Appendix IV

Drainage Impact Assessment Report
with Response-to-Comment

Section 12A Rezoning Application for Proposed Columbarium on Various Lots in D.D.41 Sha Tau Kok, New Territories

Drainage Impact Assessment Report

Figure 3.2

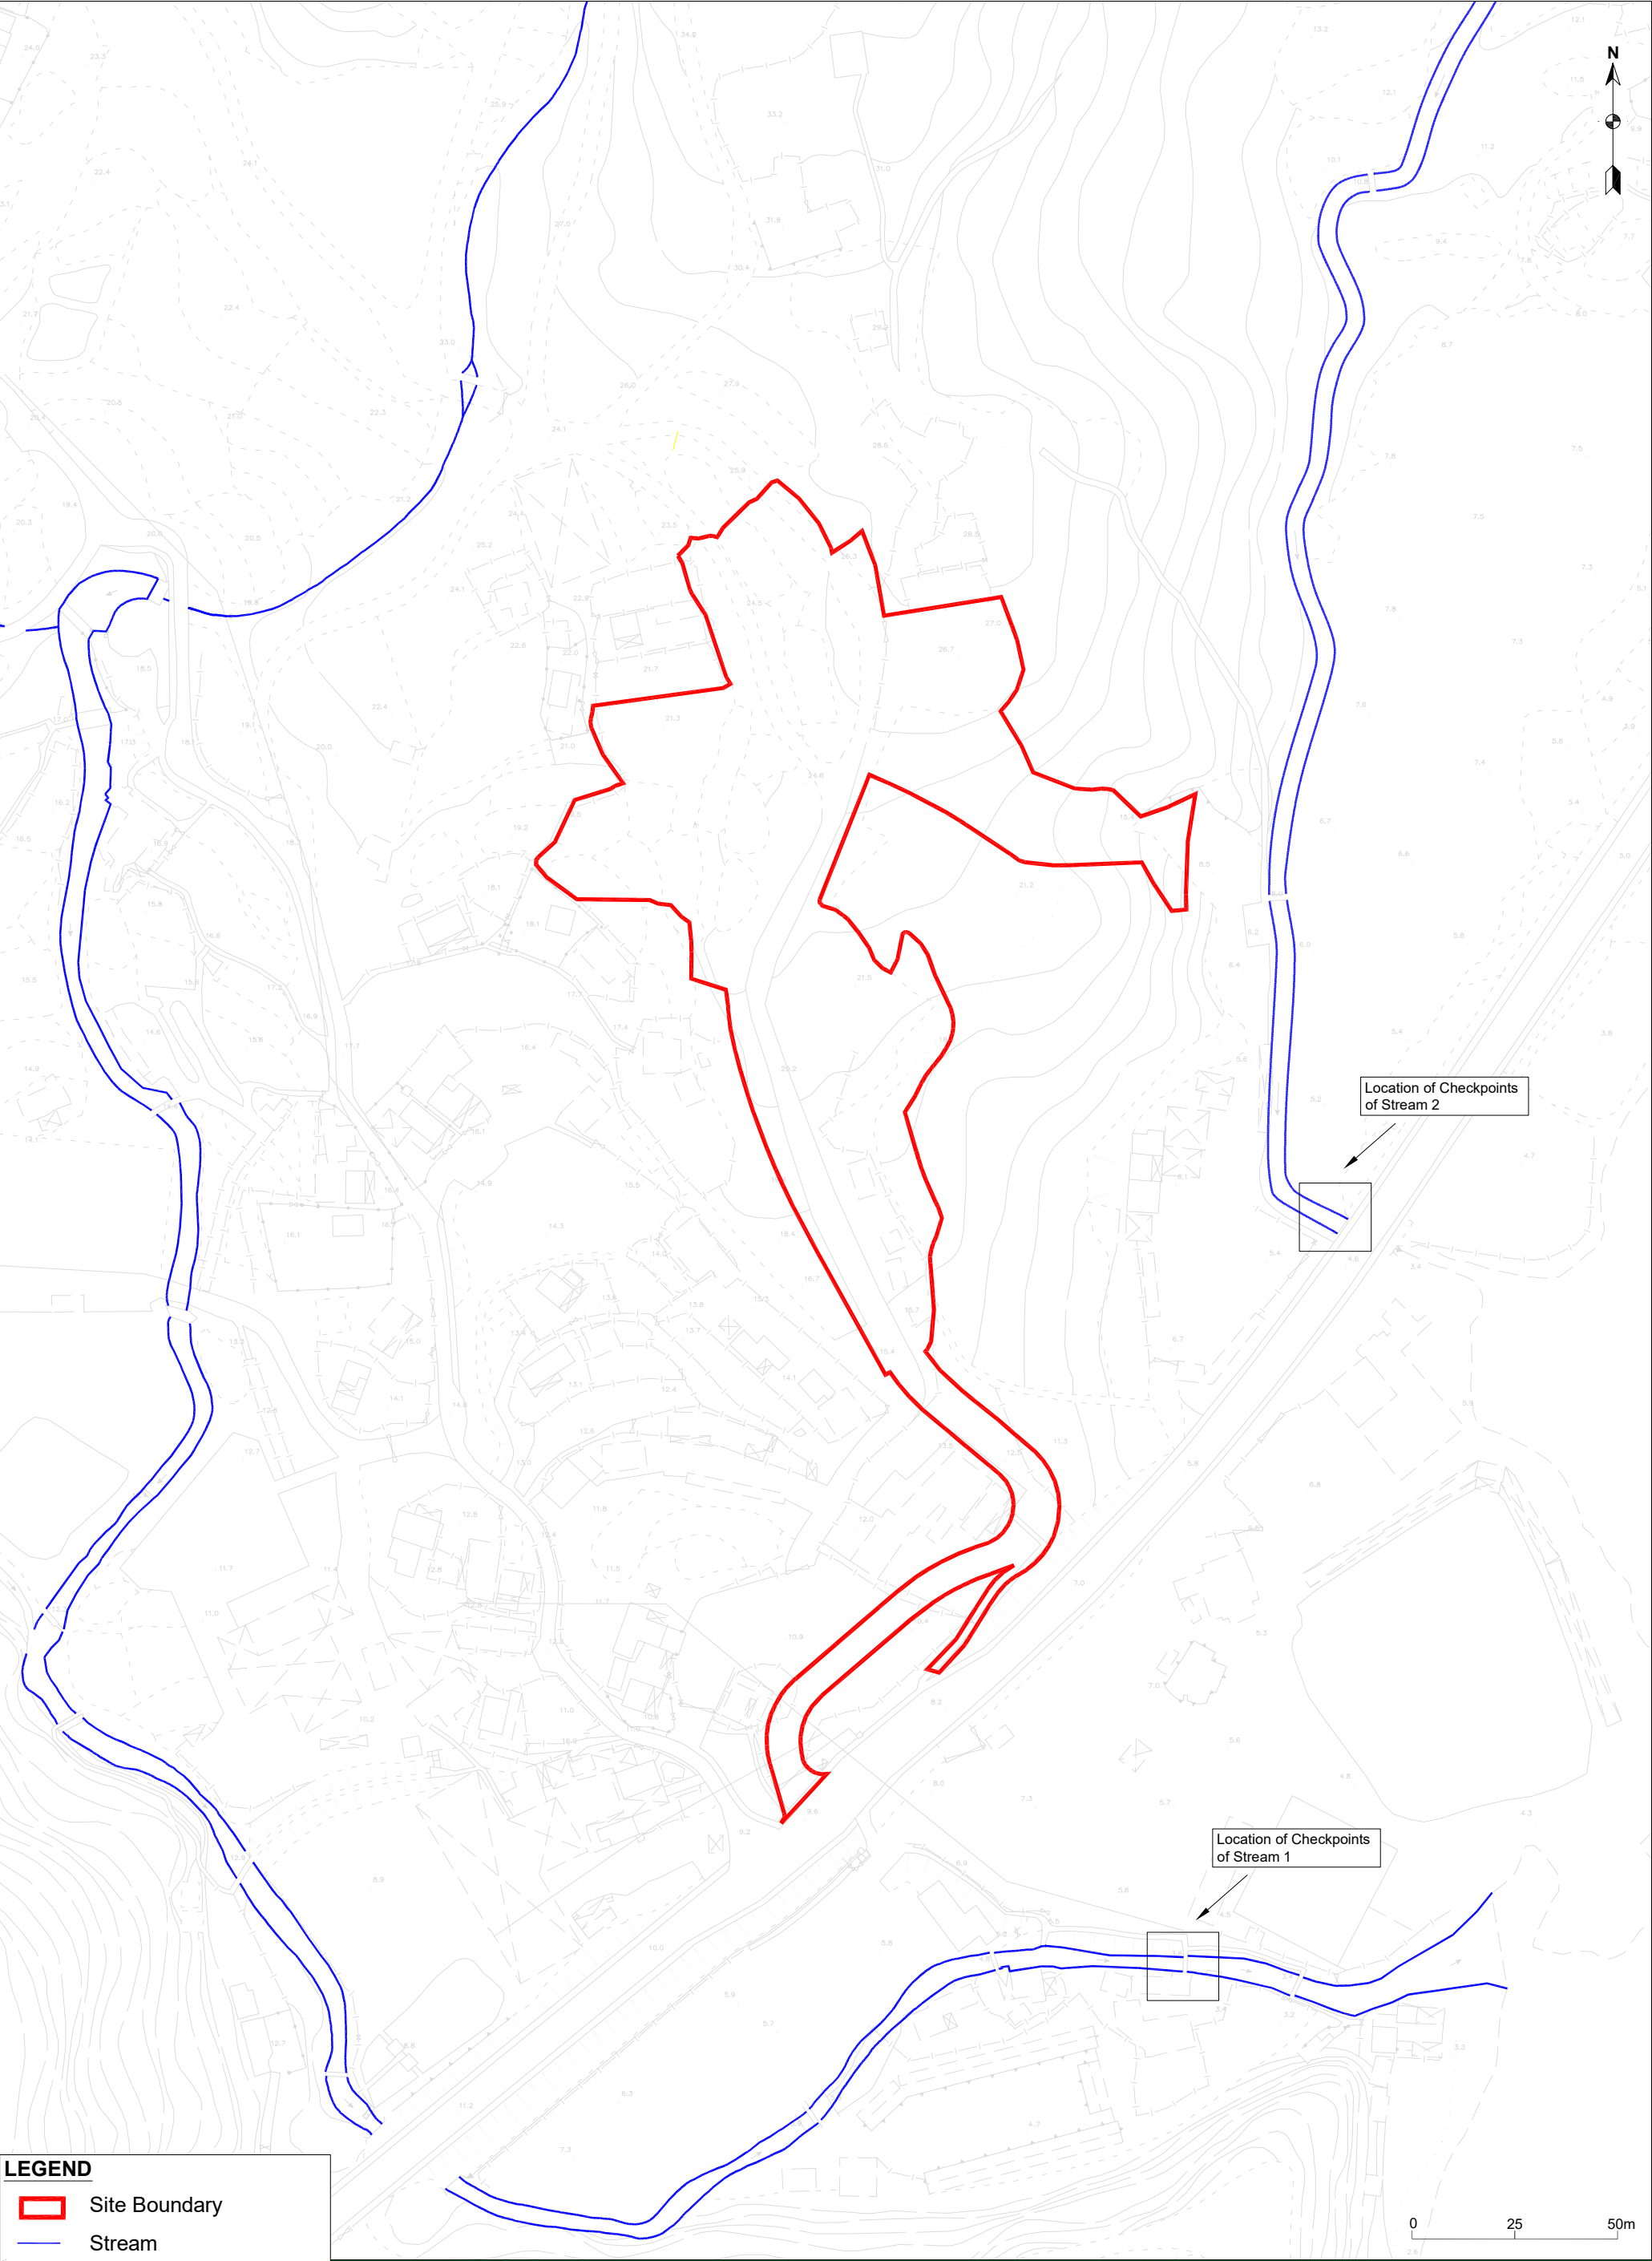
Items	Comments	Response
e	Figure 3.2 refers.	
	(i) The applicant should indicate the invert levels of the proposed catch pits and manholes.	(i) Noted and revised. Please refer to Figure 3.2.
	(ii) (ii) The applicant is reminded that the minimum cover from the surface of the carriageway to the top of the pipeline shall be 900 mm. For footway, the minimum cover shall be 450 mm.	(ii) Noted. It is confirmed that the minimum cover from the surface to the top of the pipeline is 900 mm for the carriageway and 450 mm for the footway.
	(iii) Manholes should be provided where a stormwater drain changes direction.	(iii) Noted and provided. Please refer to Figure 3.2.
	(iv) The applicant should indicate the material of the proposed underground circular pipe.	(iv) Noted and indicated. Polyethylene pipe will be adopted for all proposed underground circular pipe.

(v) The applicant should use a different legend for catch pit and manhole for clarity.	(v) Noted and revised. Please refer to Figure 3.2.
	(vi) The applicant should indicate the site formation levels and fall direction of the subject site.	(vi) Noted and revised. The details of Site formation level is provided in Appendix G.

(b) The applicant should indicate the material of the proposed underground circular pipe on this figure.	Noted and revised. It is indicated that uPVC circular pipe will be adopted in Figure 3.2.

(c) The applicant should add a legend for catch pit, which should be different from the legend for manhole.	 Noted. It is confirmed that there are different legends for manhole and catchpit. Please refer to Figure 3.2.

Items	Comments	Response
Comments on Drainage Impact Assessment from DSD		
1	Figure 3.2 refers (a) The applicant should review the design of the proposed underground uPVC pipes as their tops protrude above ground levels (e.g. at manholes A25, E1). The applicant is reminded that the minimum cover from the surface of the carriageway to the top of the pipeline shall be 900 mm. For footway, the minimum cover shall be 450 mm. (b) The applicant should review the invert levels of catch pits and u-channels with consideration of thickness of concrete cover/grating to ensure the depths of u-channels are adequate. For instance, the depth of u-channel is less than 450mm at catch pit D2. (c) The applicant should review whether u-channels along the eastern and southeastern boundary of catchment areas J and K are required to intercept the overland flow. (d) The applicant should indicate the dimensions of the proposed stepped channels.	Noted and revised. The designed cover from the surface of the carriageway and footway to the top of the pipeline is at least 900 mm and 450 mm, respectively. Please refer to Figure 3.2 and Appendix B. Noted and revised. The thickness of the concrete cover/grating has been considered in the design of the invert levels of the catchpits and U-channels. Please refer to Figure 3.2 and Appendix B. Noted and revised. U-channels are proposed along the eastern and southeastern boundaries of Catchment J and K to ensure that all overland flow within the Site and upper catchments is collected by the proposed drainage system. Please refer to Figure 3.2 and Appendix B. Noted and indicated. Please refer to Figure 3.8A – Figure 3.8C.

Figure 3.6

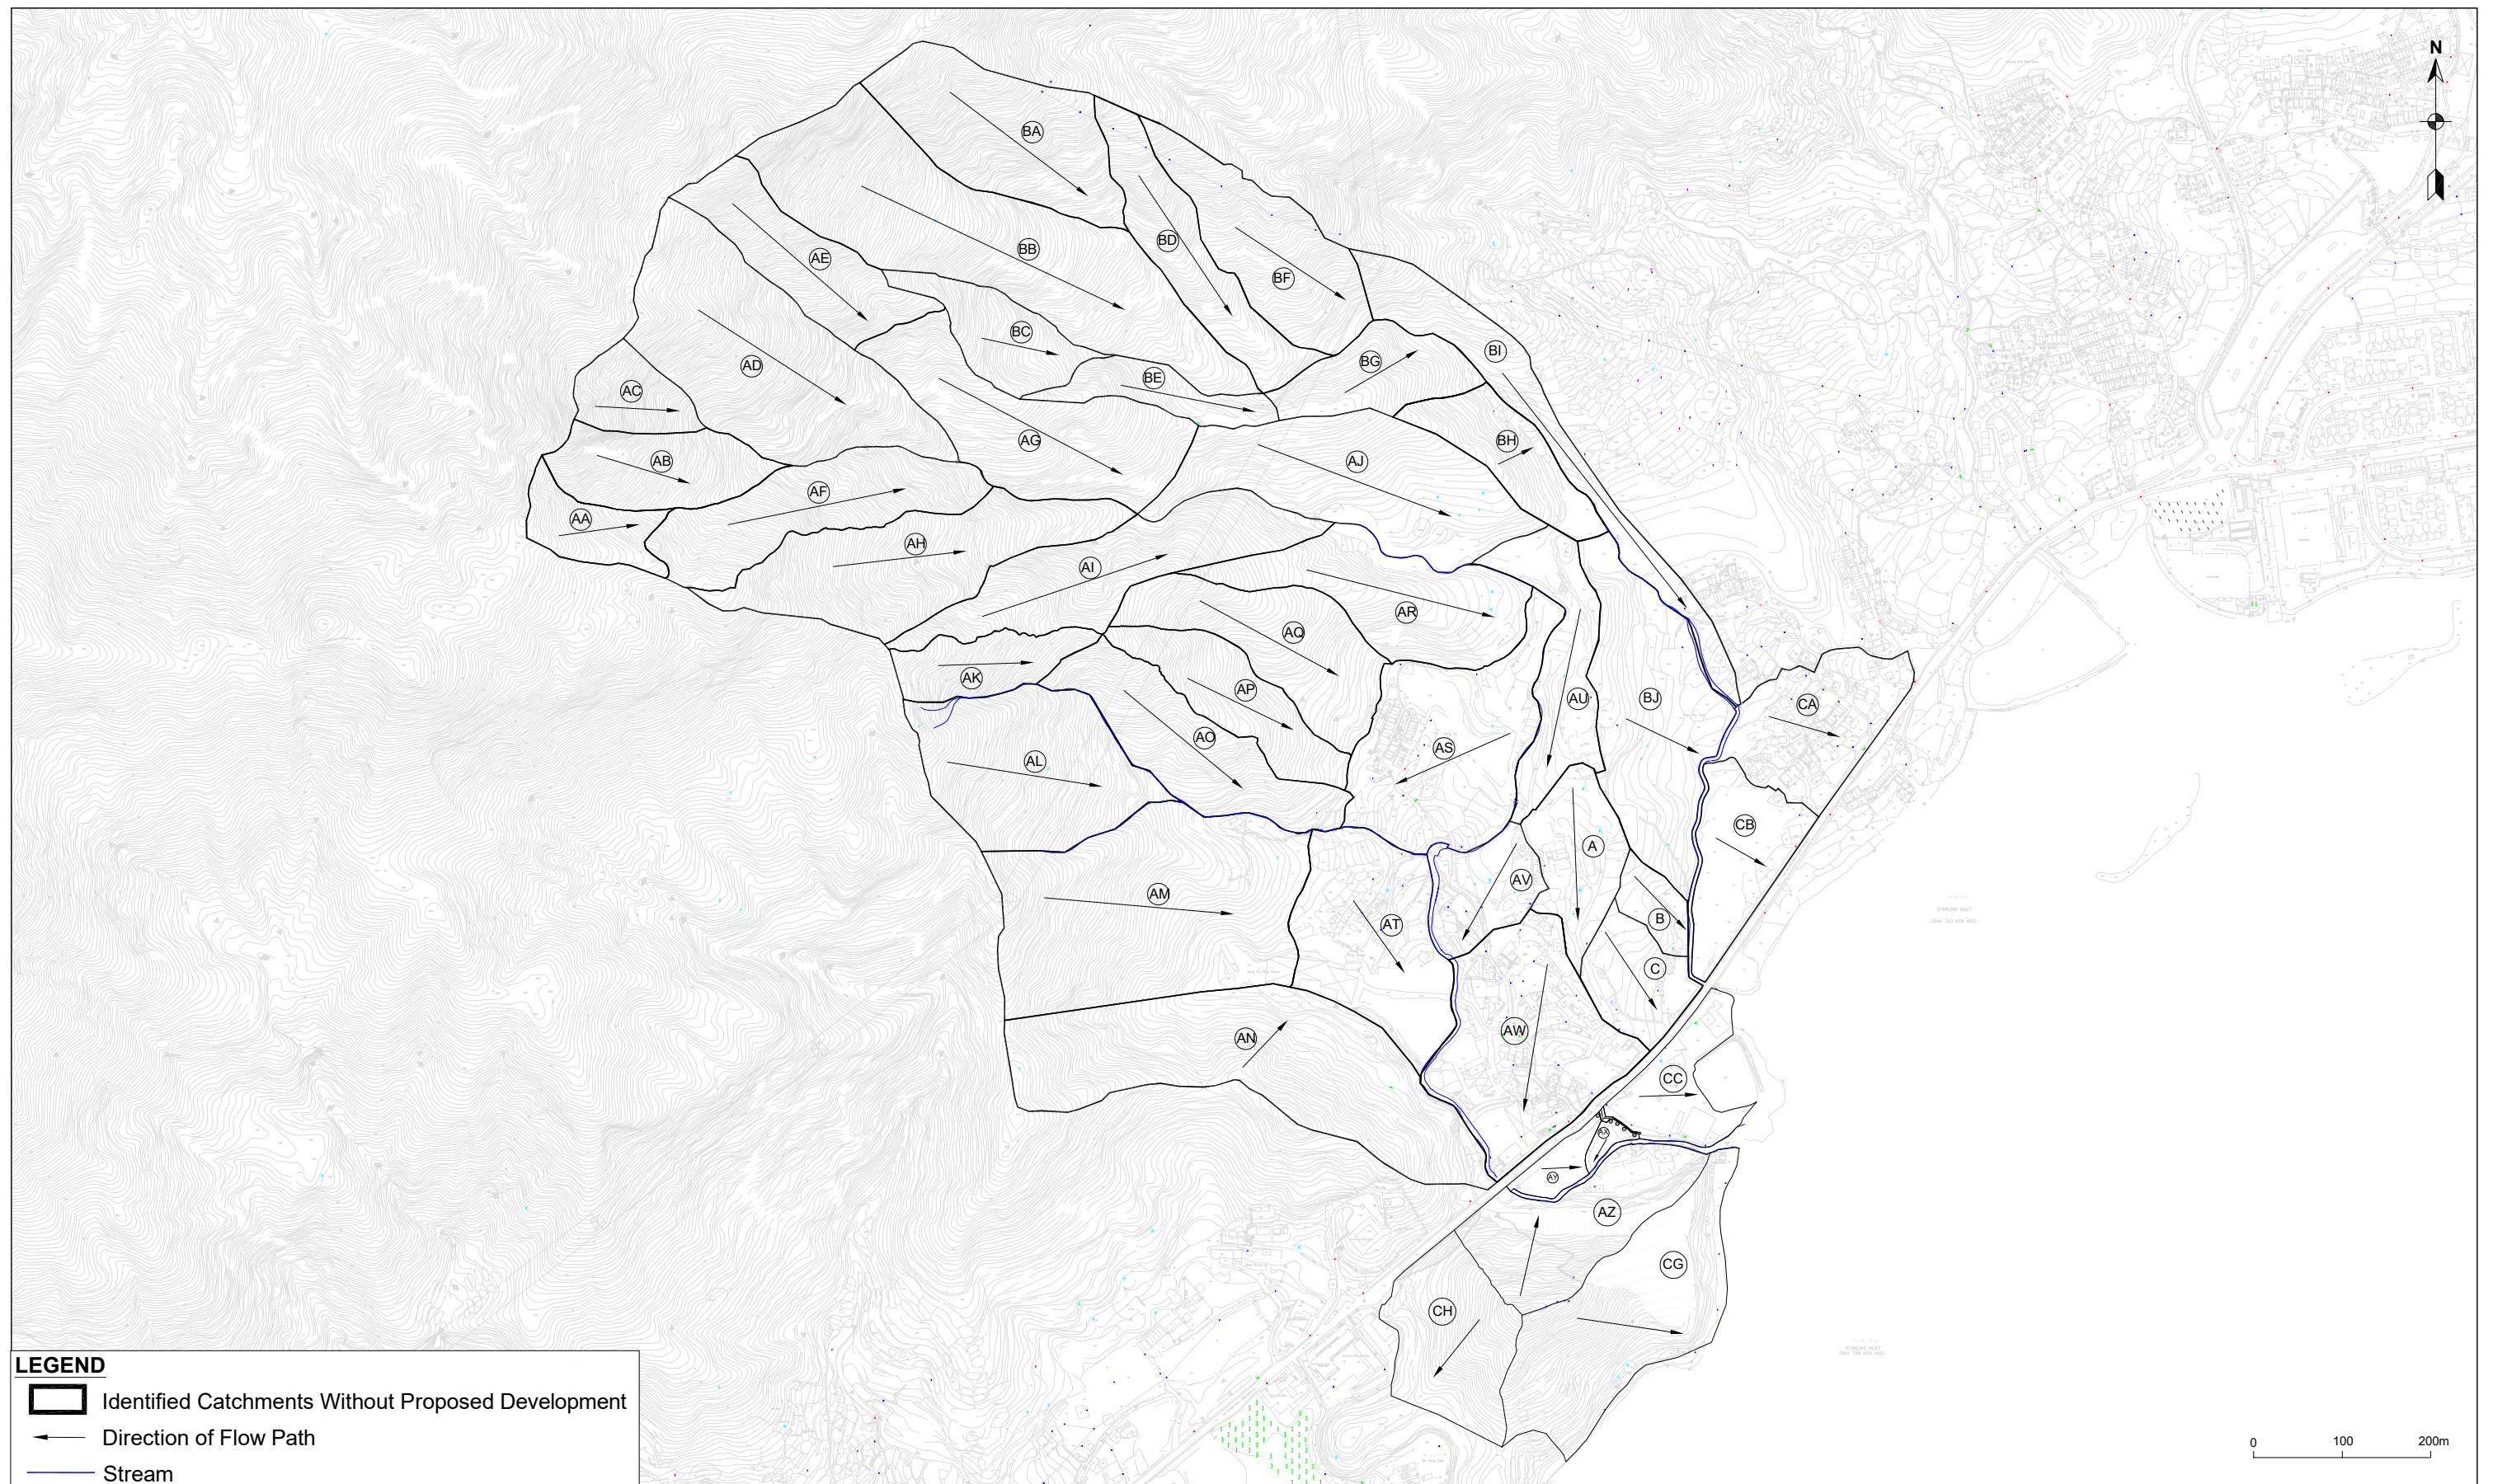
(f) RtC 2(b) and Figure 3.4 - Please confirm there is no fence wall at the boundary between manhole B5 and manhole B10 (i.e. along Catchment I)	It is confirmed that there is fence wall along the boundary between manhole B5 to manhole B10. Please refer to Figure 3.6 (new figure no.).
4	Section 3.3

2	Figure 3.6: Both the orange and green lines represent fence wall without opening. The applicant should review.	Noted and revised. The orange lines represent the fence wall with openings, while the green lines represent the fence wall without openings. Please refer to Figure 3.6.
3	Figures 3.9A to 3.9G: The site boundary should be shown in these figures.	Noted and revised. Please refer to Figure 3.10A – Figure 3.10G.
